EAST OF HUDSON WATERSHED CORPORATION

ADDENDUM #1

STORMWATER RETROFIT PROJECT

Y-MU-40

DRAWING NO. ECP-01

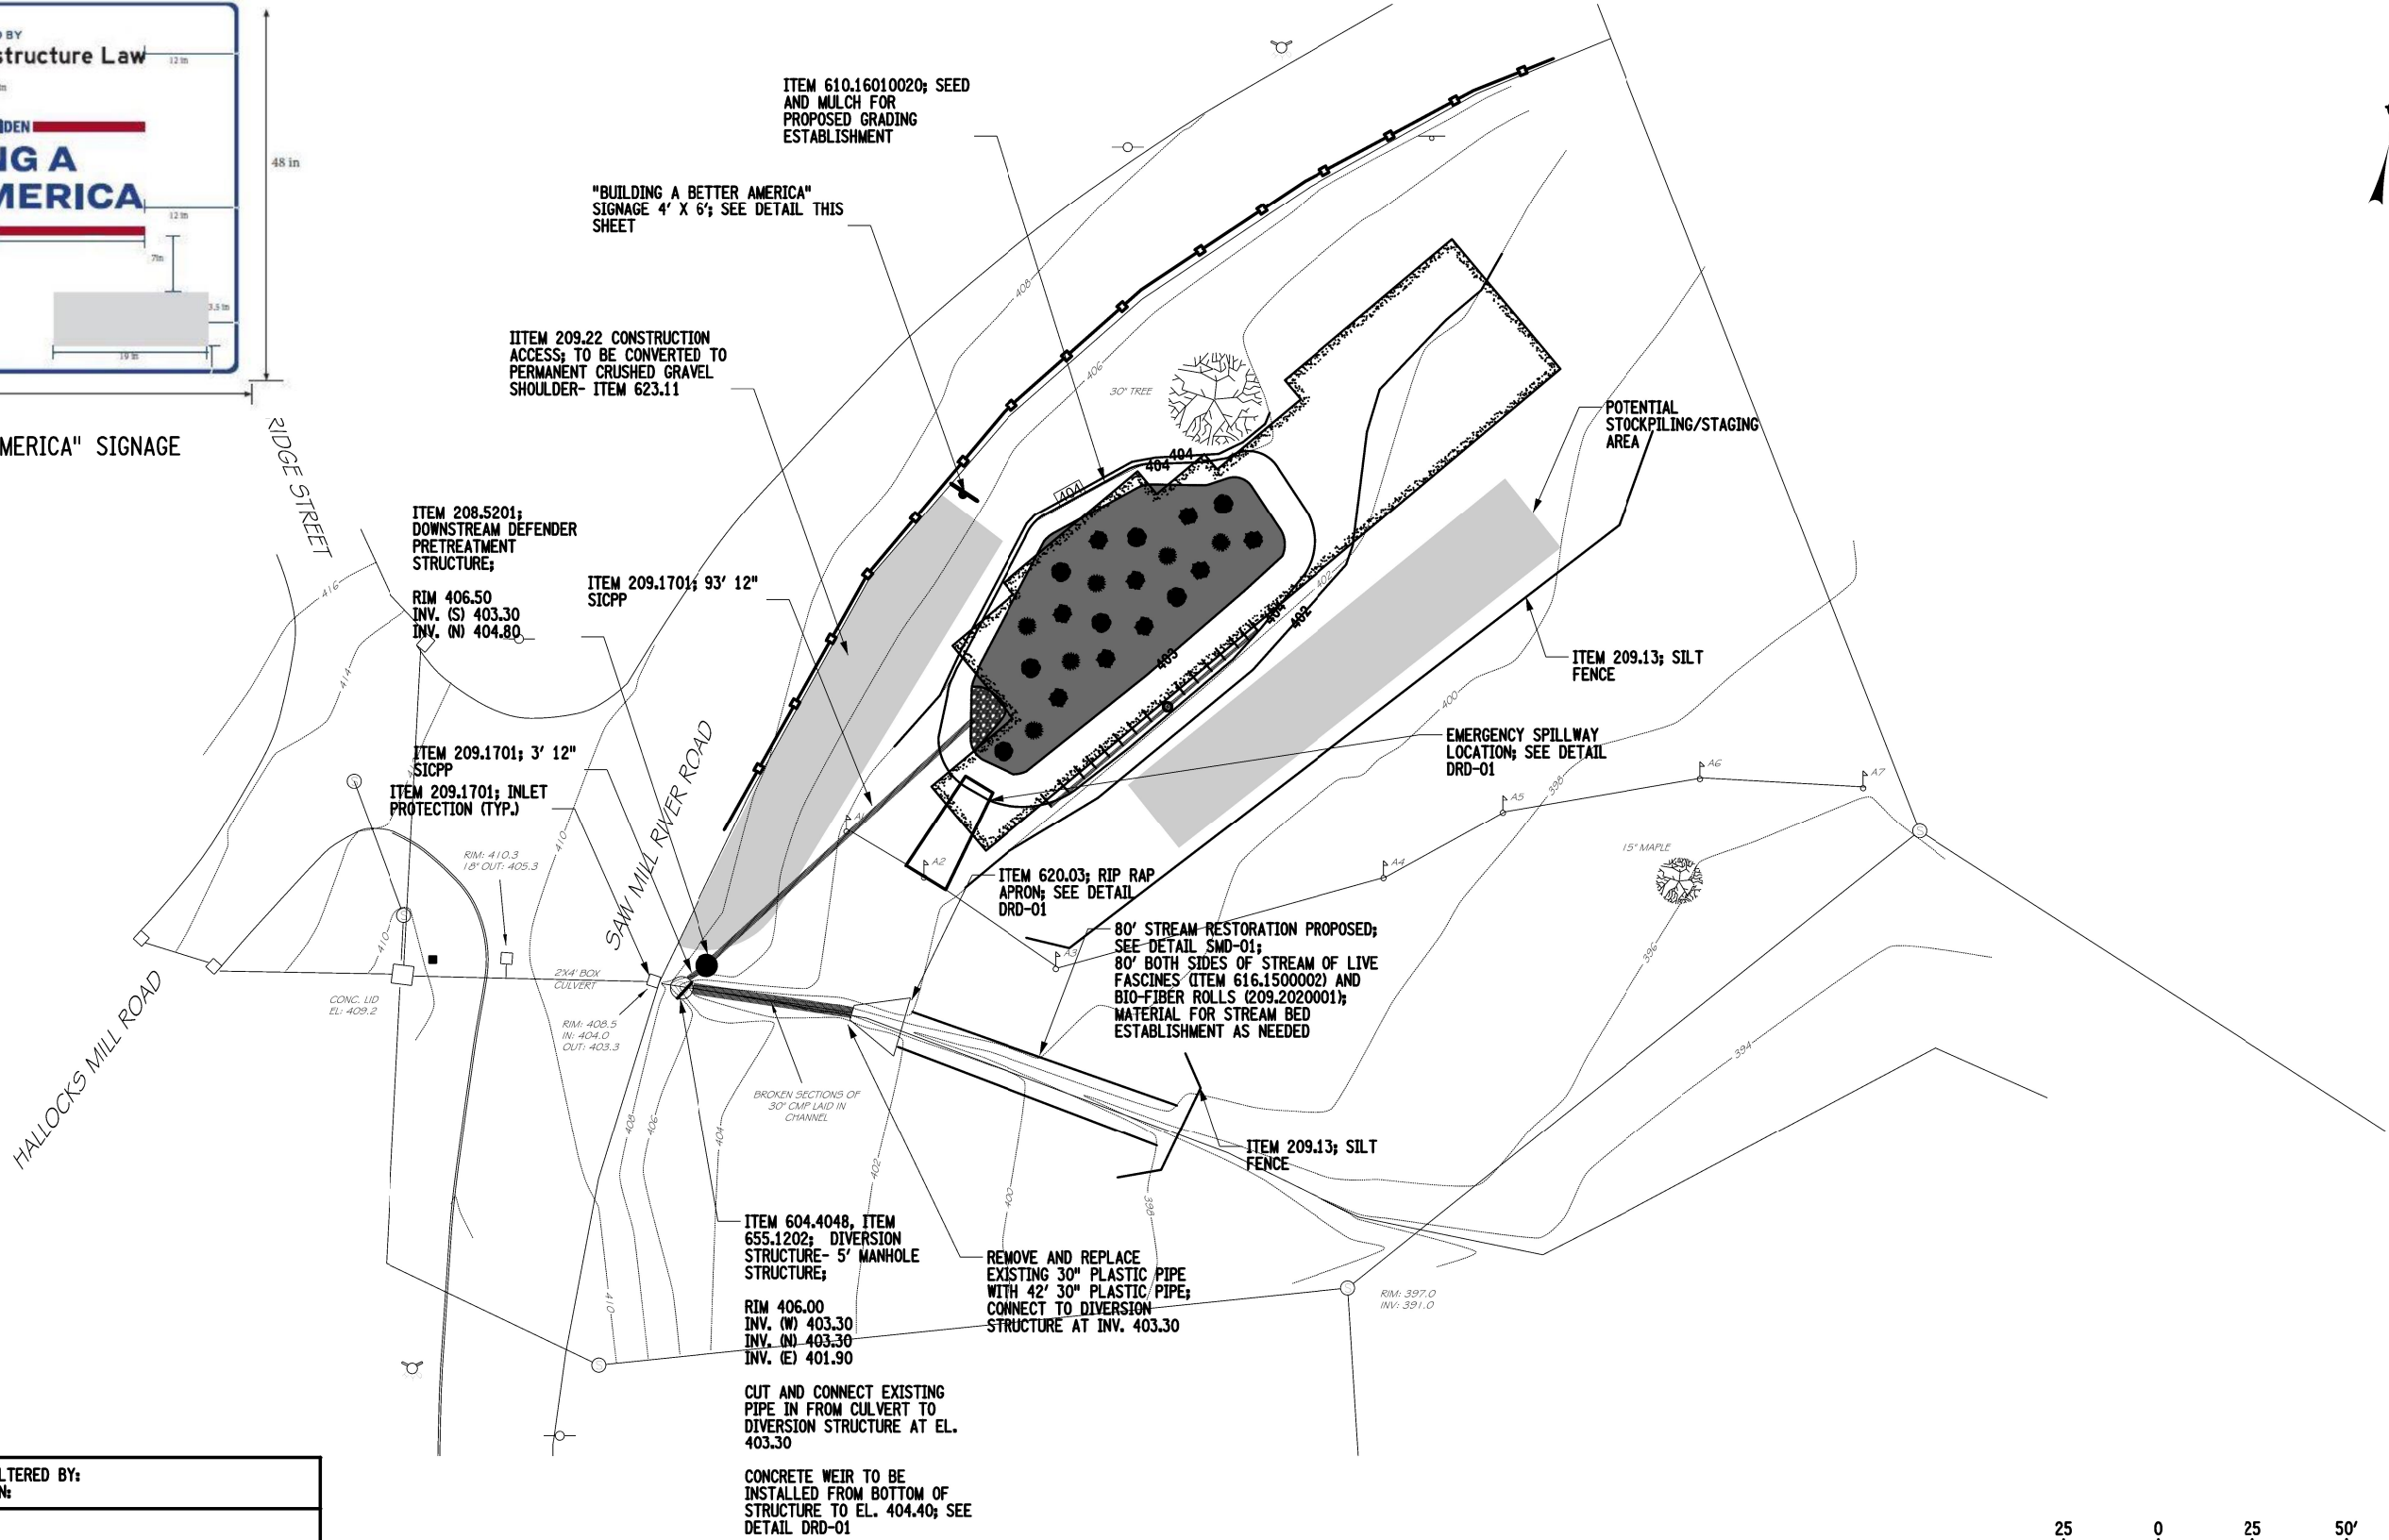
- a) *The stream bed has stone material but is not entirely stone.*
23. Please confirm that the dark lines running parallel to the stream channel on either of it on sheet ECP-01 represent the bio-fiber rolls.

- a) *This is correct.*
24. Sheet 2 of 8 for the FocalPoint System calls out an underdrain invert elevation on the elevations table, but there isn't an underdrain called out on the plans.
